ADDENDUM NO. 2

DPW Project #2023256

April 30, 2024

**DPW/UI – Ag Science Building HVAC Phase Two
University of Idaho
Moscow, Idaho**

SHEET M5.01

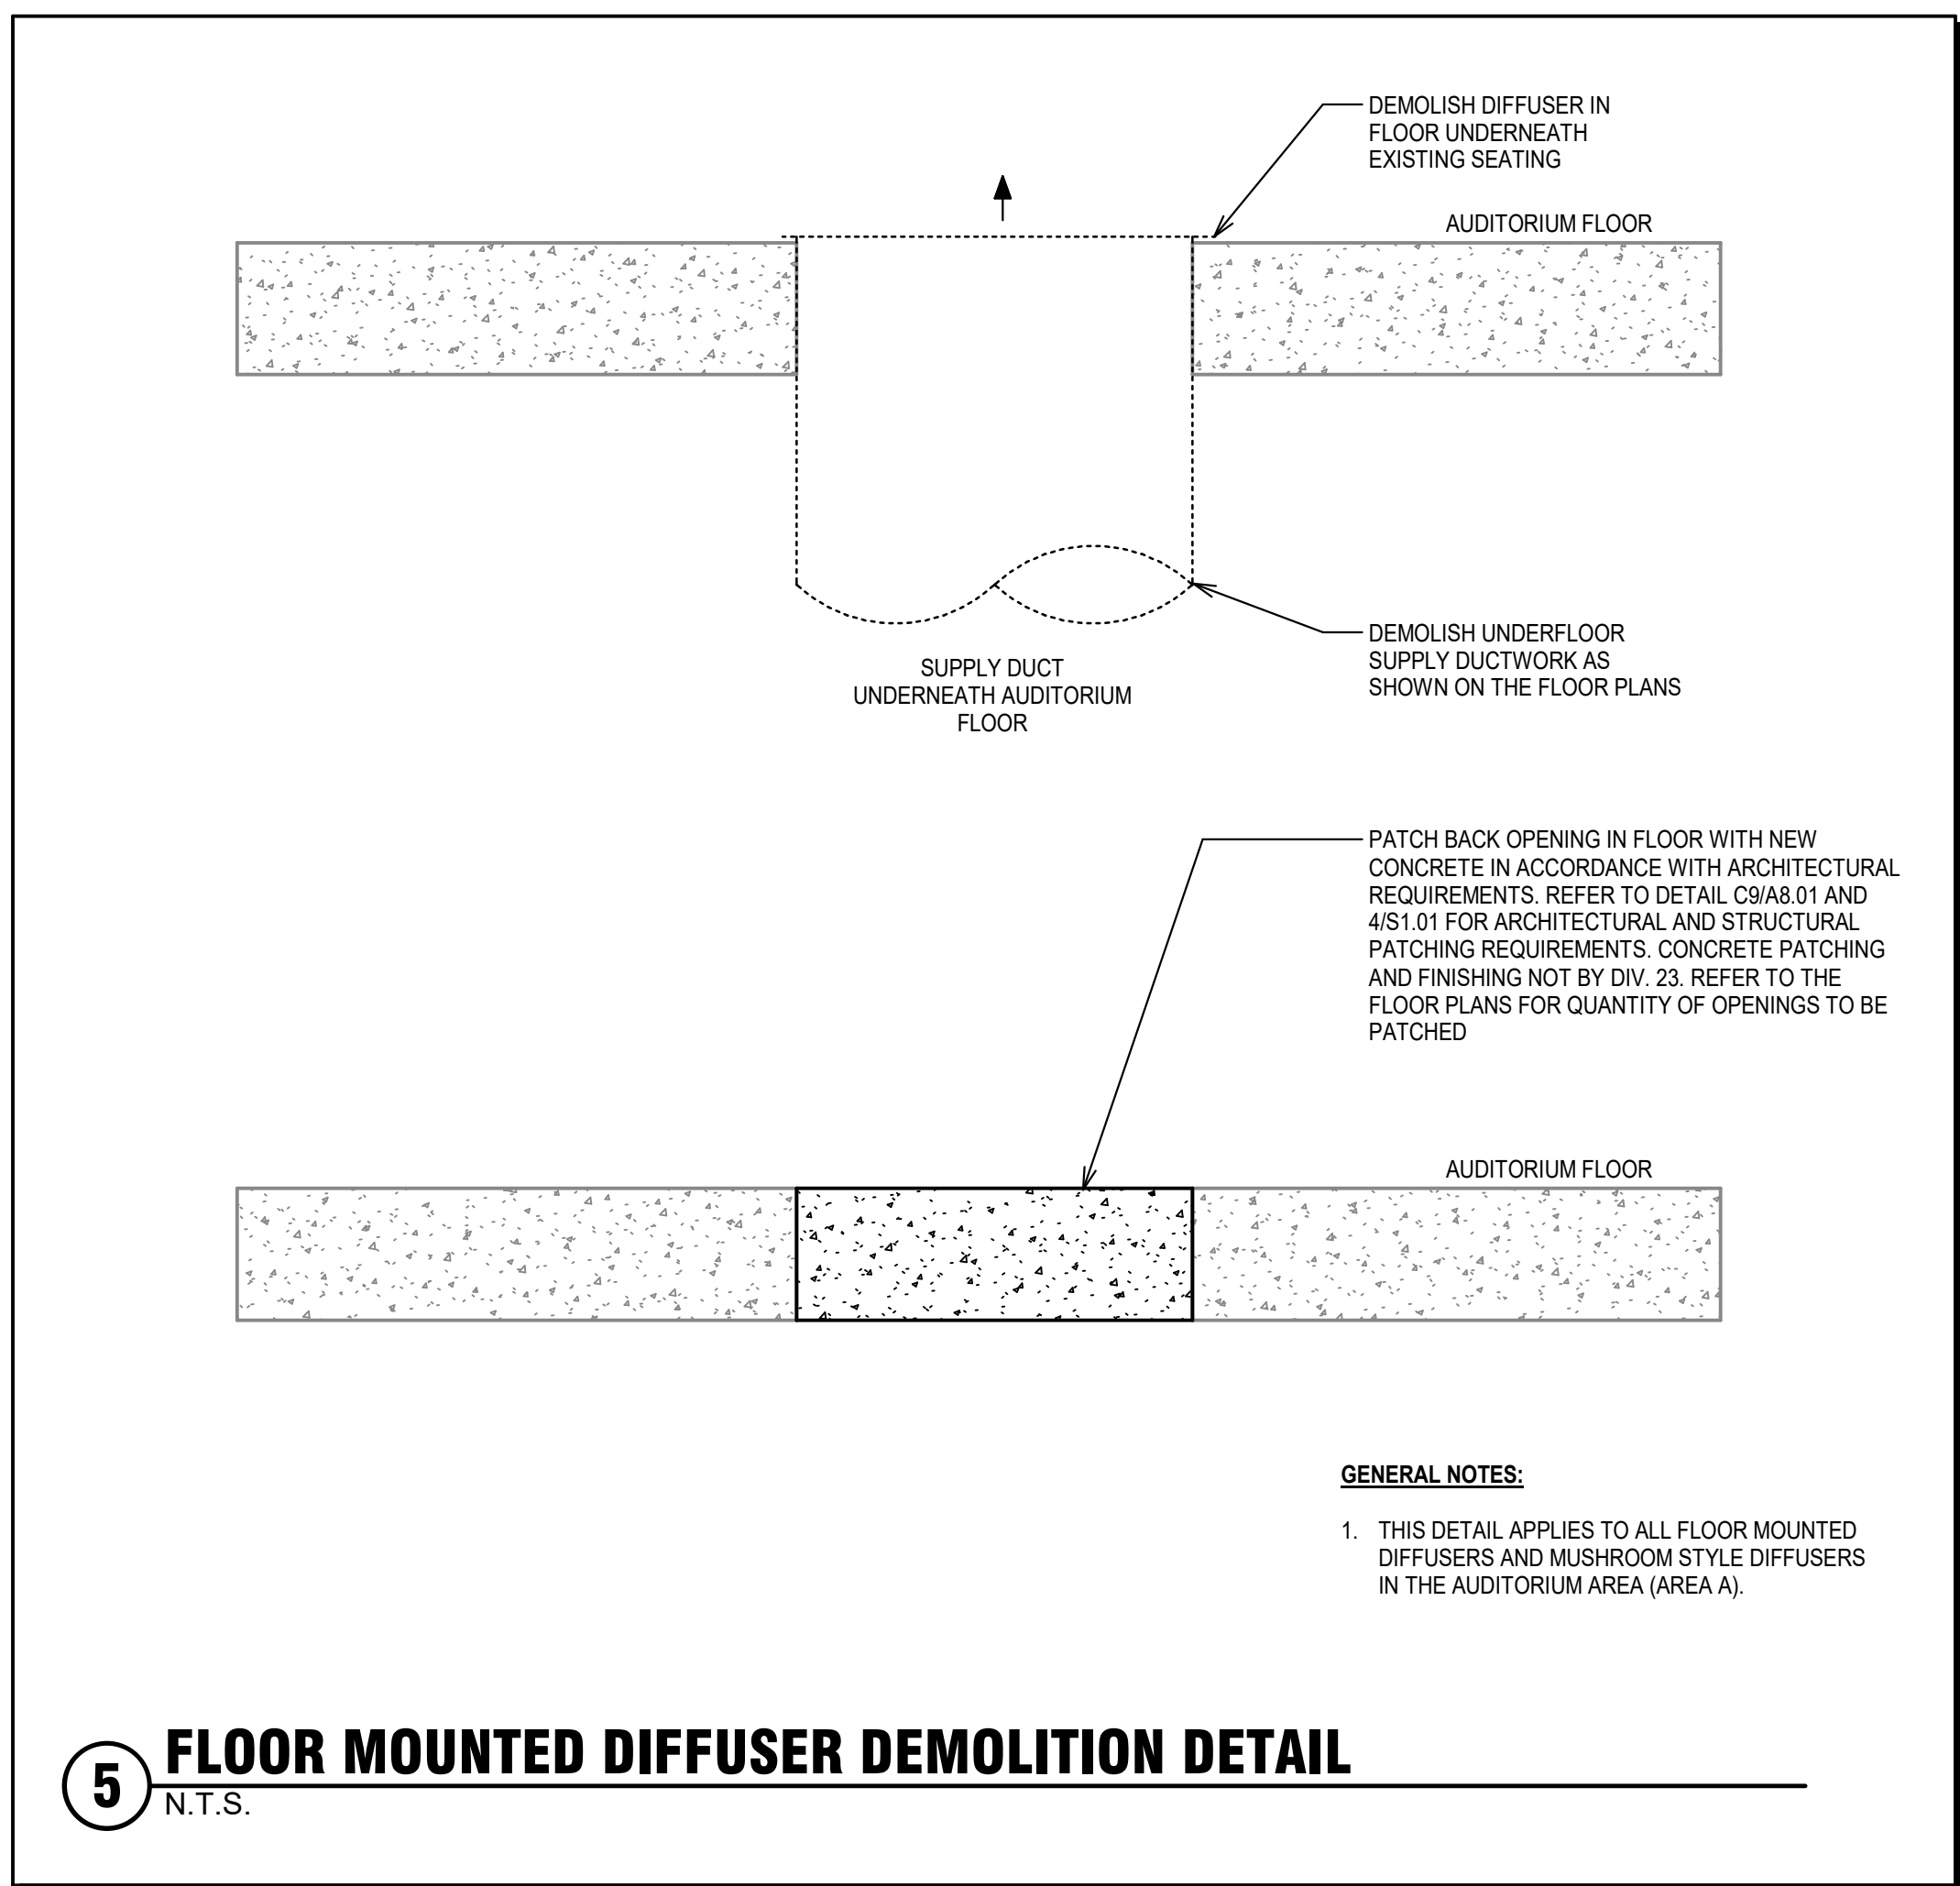
- 2.45 M4.04 - SECTIONS - MECHANICAL**
REVISION: See attached drawing with revised housekeeping pad note to indicate 6” tall housekeeping pad.
- 2.46 M5.01 - DETAILS – MECHANICAL**
REVISION: Revised detail to indicate unions on detail #4. See attached drawing.

REVISION: Revised detail to indicate unions and clarify drain valve location on detail #5. See attached drawing.

ADDITION: Added flexible pipe connectors on detail #3. See attached drawing.

DELETED: Deleted reference to maximum mounting height for drain valve in detail #7. See attached drawing.
- 2.47 M5.03 - DETAILS – MECHANICAL**
ADDITION: Added flexible pipe connectors and manual balancing valve on detail #4. See attached drawing.

SHEET
E3.52A

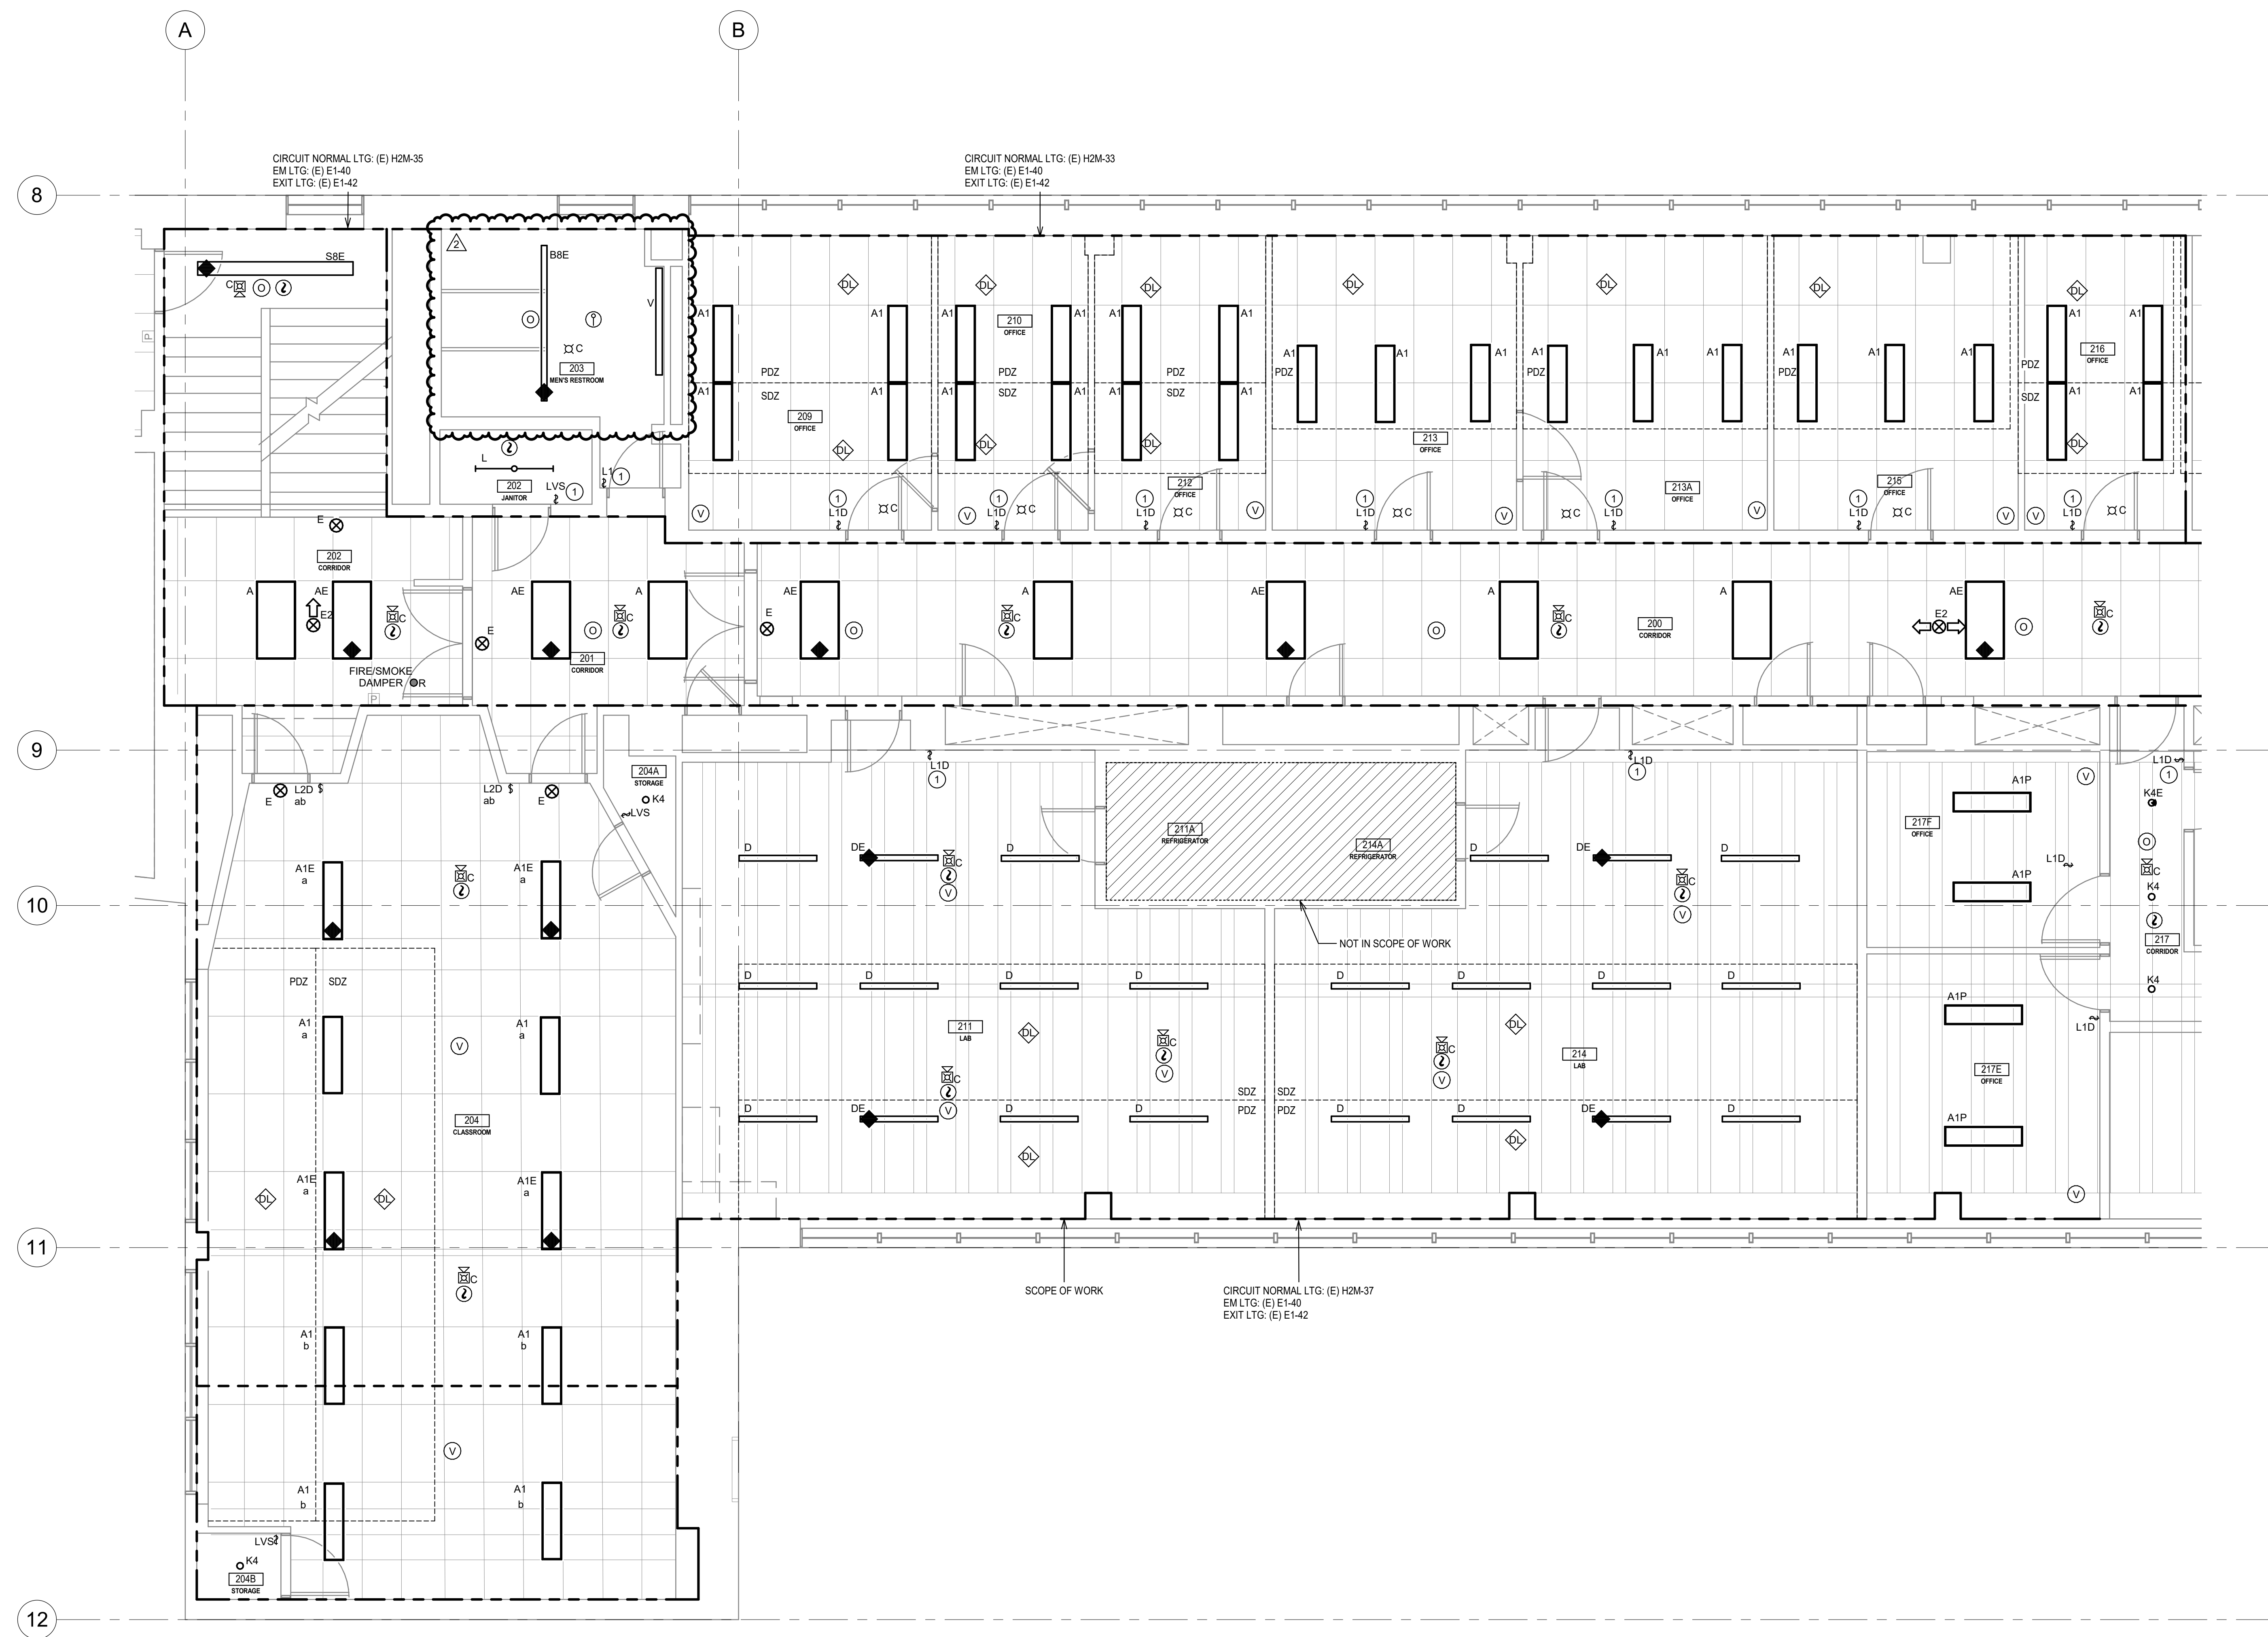
- 2.59 SHEET E3.52A – SECOND FLOOR AREA A – LIGHTING**
REVISION: Revised Auditorium cove lighting type to W-2, W-3, and W-4. See attached drawing.
- REVISION: Revised cove light locations in ceiling to match architectural RCP. See attached drawing.
